YS-049-06
Fix on Fail Only
Expires 12/31/07

SUBJECT: 2-5 Ton Champion Gas heat – Electric Cool Units With ECM (Variable Speed) Motors periodically failing to run on a call for cool.

UNITS: All 2-5 Ton Champion / Affinity Gas Heat – Electric Cool units.

COOLING UNIT WITH GAS HEAT

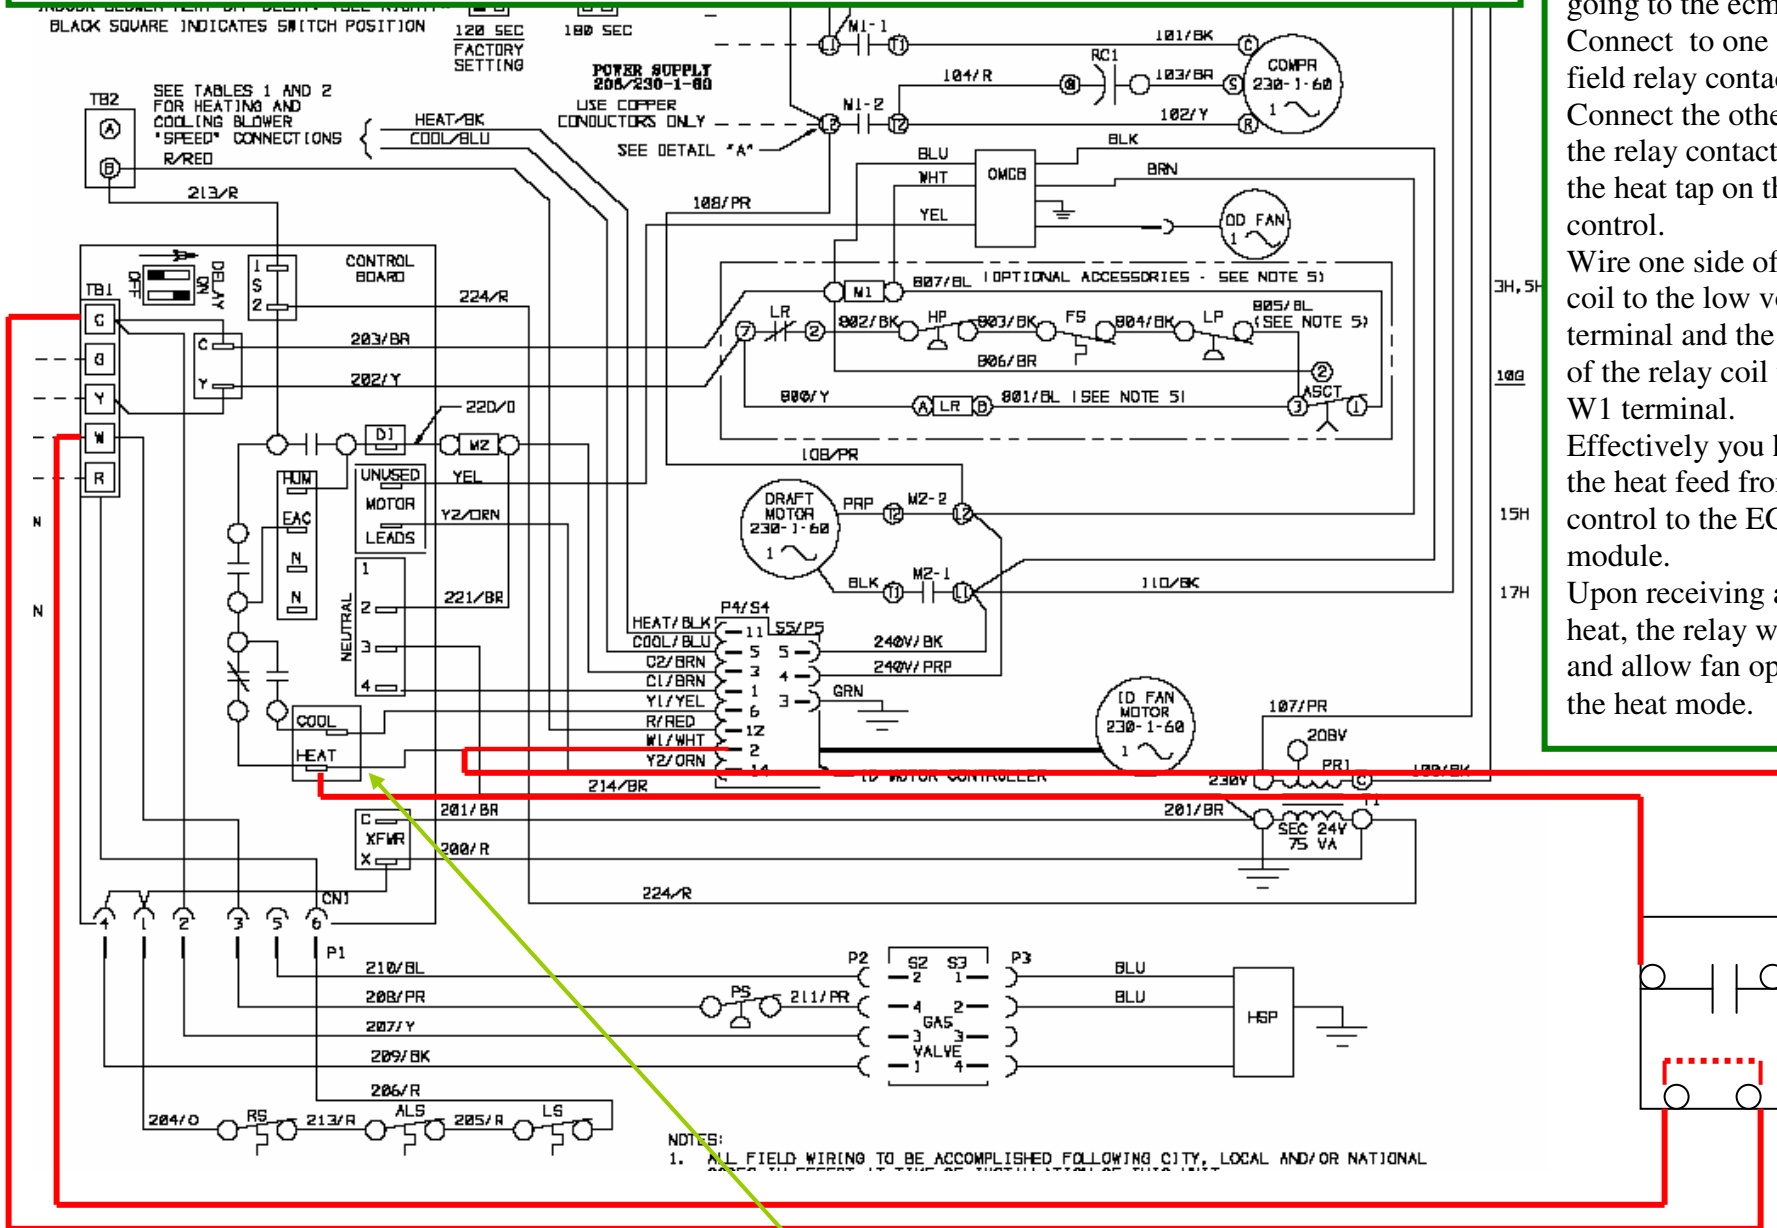
Gas / Electric Champion packaged units with ECM motors. Single Stage.
 Field fix for motor not running in cool mode.
 Use relay with NO contacts with 24 vac coil. S1-090-360 or equivalent.

Wire to be disconnected. See instructions above

Mount field supplied relay with 24 vac coil, and normally open contacts. Remove wire from heat tap on the HW control board going to the ecm module. Connect to one side of the field relay contacts. Connect the other side of the relay contacts back to the heat tap on the HW control. Wire one side of the relay coil to the low voltage "C" terminal and the other side of the relay coil to the W or W1 terminal. Effectively you have broken the heat feed from the HW control to the ECM motor module. Upon receiving a call for heat, the relay will close and allow fan operation in the heat mode.

ELEMENTARY DIAGRAM

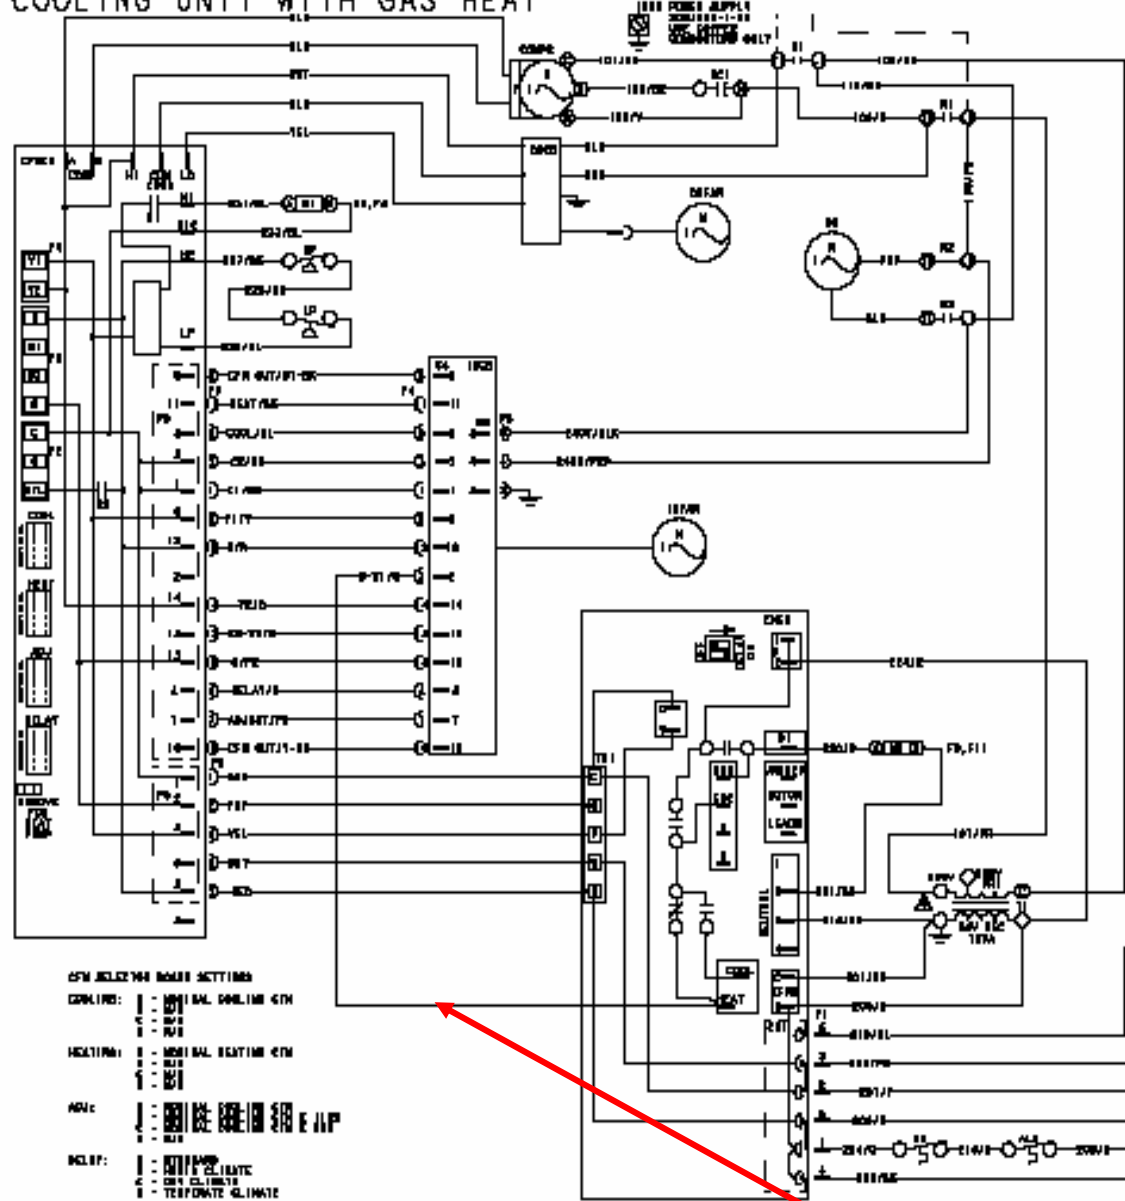
Champion Gas heat – 2 Stage Cooling unit with the CFM Timer board.
 Same procedure as above. Add relay and break wire from the Terminal marked “Heat” on the Honeywell module through the normally open contacts.
 Activate the relay with the Call for heat on W1 terminal where the thermostat is tied into the CFM timer board.

Break this wire with the Field installed relay. Normally Open Contacts.
